APPEAL LETTER

Application for Appeal (DS-210)

RE: Appeal of the Final EIR Certification for Murrieta Costco/Vineyard II

Subject: Comments on the Costco/Vineyard II Retail Development Project (SCH No. 2018061602)

Figure #1: 2014 Statewide All Fleet Sizes (Pieces of Equipment)

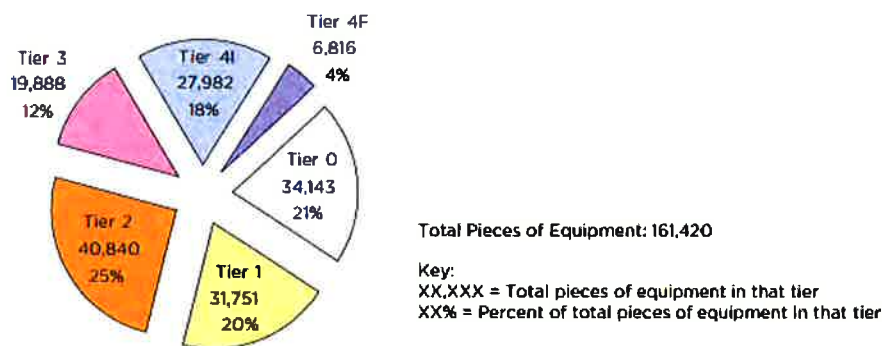
As you can see in the excerpt above, the DEIR acknowledges that Tier 4 Final equipment may not be readily available for use at the Project site. As such, due to this limited availability, the DEIR should have assessed the feasibility in obtaining equipment with Tier 4 Final engines to ensure that this measure can actually be implemented for the proposed Project (see excerpt below).⁵

As demonstrated in the figure above, Tier 4 Final equipment only accounts for 4% of all off-road equipment currently available in California. Thus, emissions are modeled assuming that the Project will be able to obtain 28 pieces of Tier 4 Final equipment even though this equipment only accounts for 4% of all available off-road equipment currently available in California. As a result, the model represents the best-case scenario even though obtaining this type of equipment may not be feasible. This is incorrect,
